FutureGen Response to
Informal Request # 3

From: Gilmore, Tyler J [Tyler.Gilmore@pnnl.gov]
Sent: Friday, January 17, 2014 4:06 PM
To: McDonald, Jeffrey
Cc: Greenhagen, Andrew
Subject: Re: Informal Request (IR) # 3 (IR3-01-10-14)
Attachments: EPA_IR3_for_FG-RPT-017-Final.pdf

Determination of the Top of the Injection Zone, based on Geophysical Logs and Modeling Results

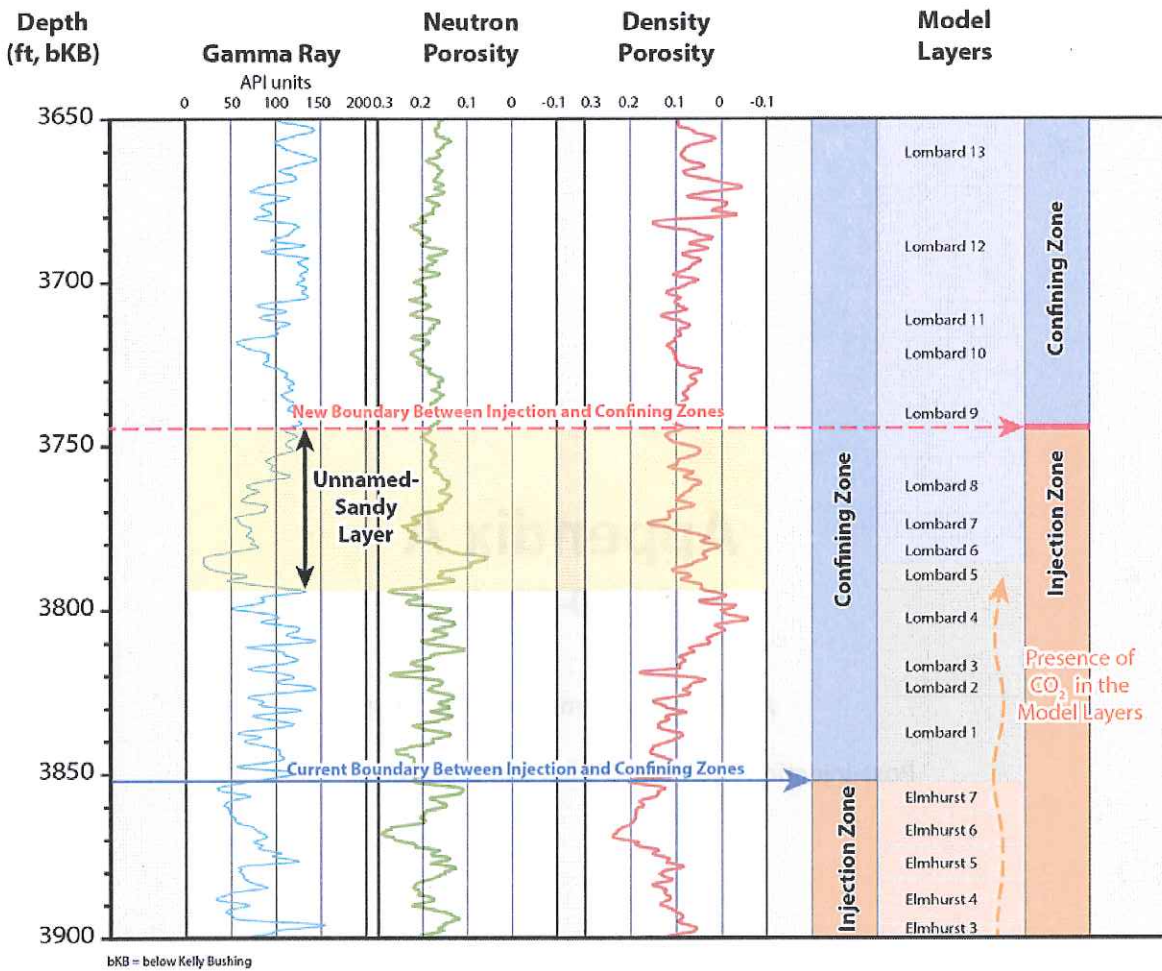
01-10-2014: Email from Jeff McDonald (U.S. EPA Region 5) to Tyler Gilmore (Alliance): "Informal Request (IR) #3 (IR3_01-10-14)"							
Requests based on the text application							
IR #	Subject	Page	Doc. Sec.	Par.	EPA Comment / Question / Request	FutureGen Response	Footnote / Reference Citation
01-10-2014_5	PISC	3.27 to 3.34	7.1.3 and 3.1.6		"The computational model results indicate that a small fraction of the injected CO2 will enter the lower part of the Lombard formation, if authorized under any UIC permits; the injection zone will need to include that lower part of the Lombard. Please determine what members or submembers of the Lombard are expected to receive CO2 and will therefore be part of any permitted injection zone."	The computation model results indicate that the Model Layer "Lombard 5" is the top unit containing a fraction of injected CO2 during the 100-year simulation. However, because geophysical logs indicate the presence of an unnamed thin sandy layer above Lombard 5 (see graphic in Appendix A), the Alliance determined that this thin sandstone should also be part of the injection zone. In conclusion, based on the current knowledge of the geology at the FGA1 stratigraphic well, the top of the injection zone is set at 3,745 ft bKB (or 3,731 ft below ground surface), which is in the lower part of the model layer "Lombard 9" (Appendix A) KB = below Kelly Bushing

Figure 2. Updated and Revised Plan for Monitoring Wells.

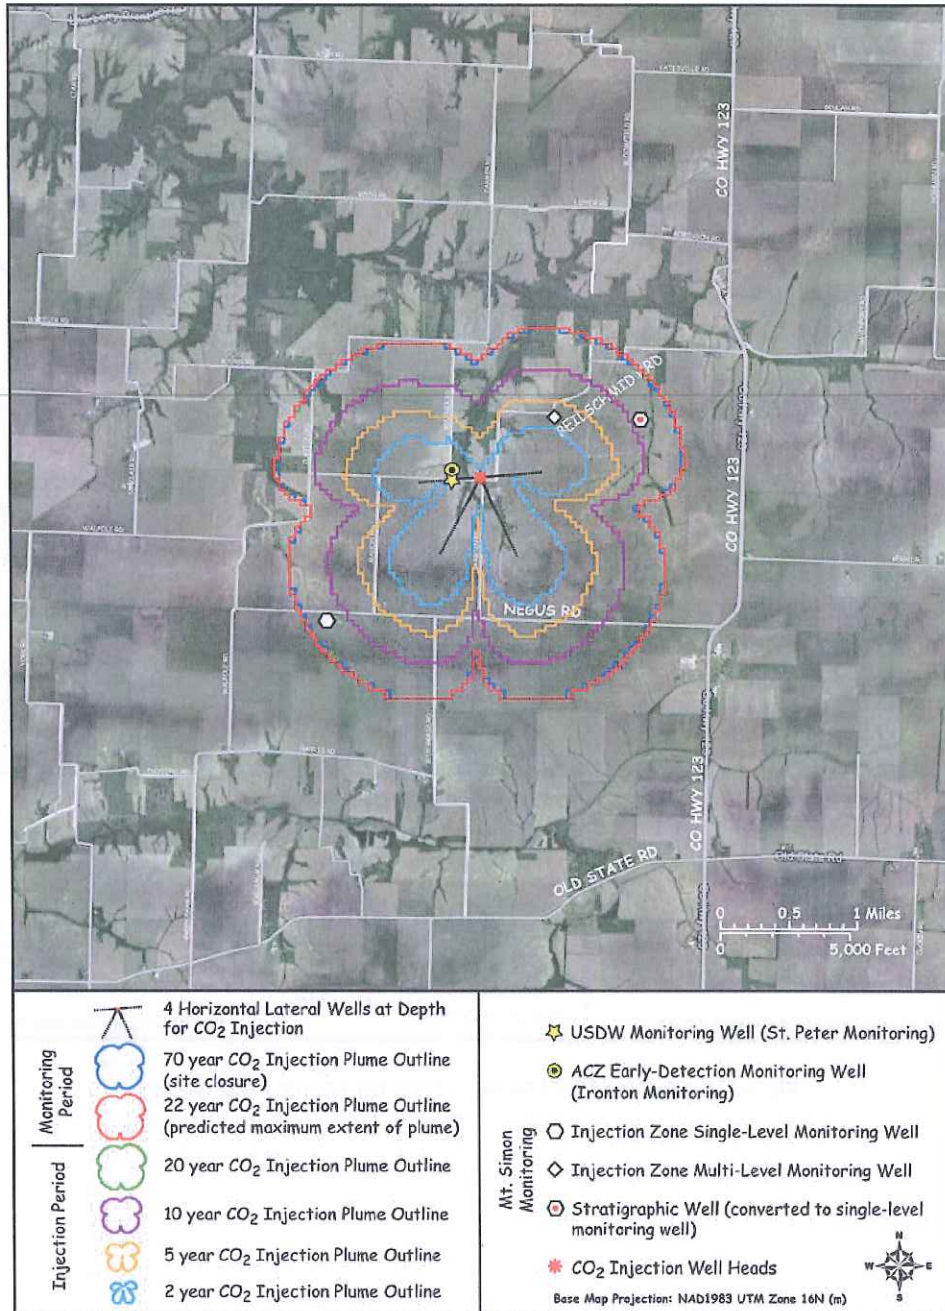
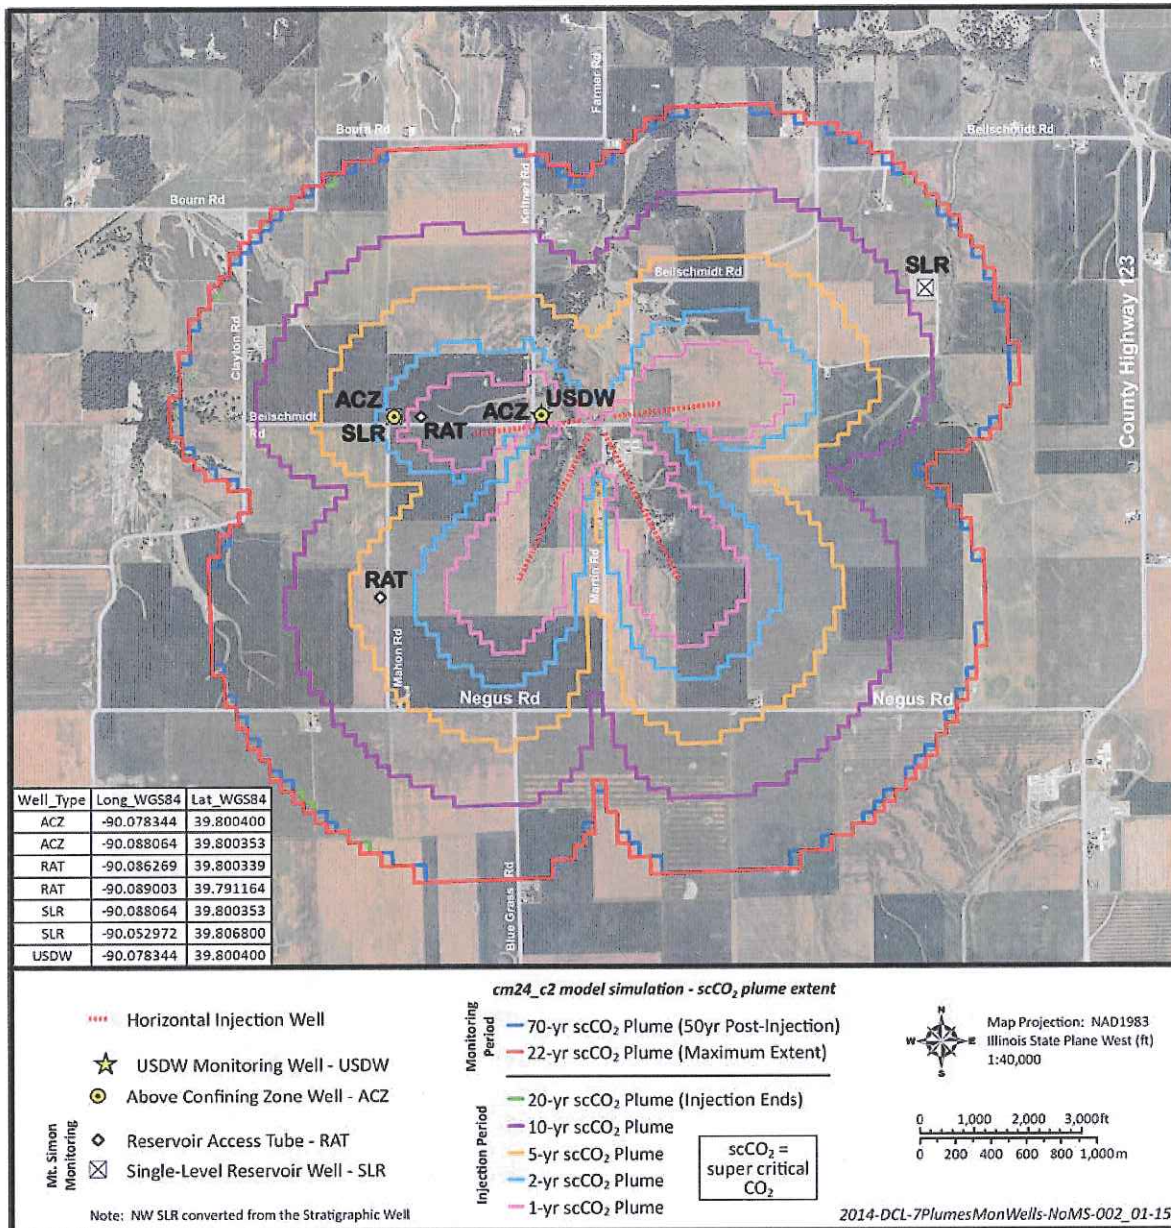
01-10-2014_6	PISC and T&M	7.5	7.2 and 5.2		"Specific locations of monitoring wells need to be identified for any permit decision including what specific parameters will be monitored for."	The Alliance has modified the monitoring network design since the UIC permit application was submitted. A discussion, which includes monitored parameters, and a location map showing the updated and revised monitoring well network are provided in Appendix B .	
01-10-2014_7	PISC and T&M	7.5	7.2.2		"Please state whether FGA will use a "multi-level monitoring system within a single casing string with multiple sample intervals," or a "multi-level piezometer installation."	The Alliance has modified the monitoring network design since the UIC permit application was submitted by eliminating this "multi-level monitoring well". The previously planned multi-level completion has been replaced by two fully cased reservoir access tubes (RATs) that will be installed within the boundaries of the simulated 5-year CO2 plume. The RATs will extend to the base of the reservoir and into the Precambrian bedrock. The RATs will be non-perforated, cemented casings used to monitor CO2 arrival and quantify saturation levels via downhole pulsed-neutron capture (PNC) geophysical logging across the reservoir and confining zone.

As part of the project's design optimization, the monitoring well network design has been revised (Figure 2) to increase its effectiveness, simplify its engineering design, and hopefully eliminate any permitting challenges that might have been associated with the MLR. The revisions include eliminating the MLR well in favor of adding two fully cased reservoir access tube (RAT) wells. The revised design includes a total of seven monitoring wells summarized in Table 1 and as follows:

The most recent monitoring well design includes five deep monitoring wells and two RAT wells as listed in Table 1.
